Service Bulletin No. 452

MODEL J4500	TYPE Field Change Program	SECTION/GROUP 12-Suspension	DATE
SUBJECT FRONT SWAY BAR			
CONDITIONS

Ref. MCI NHTSA Recall No.:17V-207

Figure 2. Sway bar installation.

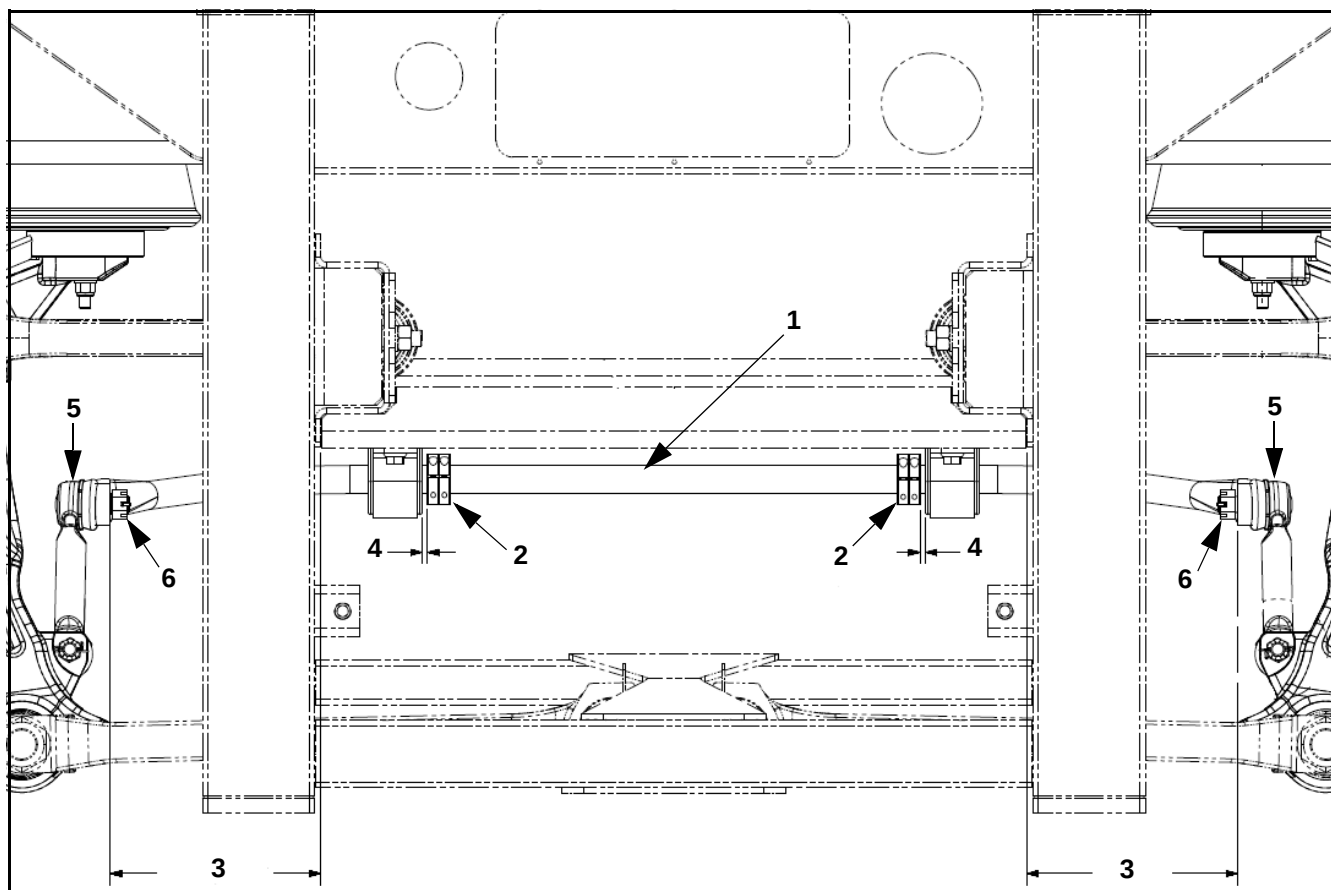
DO NOT remove the existing sway bar links (refer to Figure 2 / Item 5).

Loosen only, DO NOT remove the existing nut from the sway bar link assembly (refer to Figure 2 / Item 6).

3. Remove and discard the existing front axle sway bar.
4. Install the new sway bar and service kit components as shown in Figures 2 and 3.

Item	Figure 2 Description
1	Sway bar
2	Collar. Torque collar allen bolts to 155-175 in-lbs.
3	Distance of 9.37 inches
4	Distance of 0.25 inch
5	Existing swaye bars links. Ensure sway bars links are vertical and spaced equally from uprights.
6	Existing nut
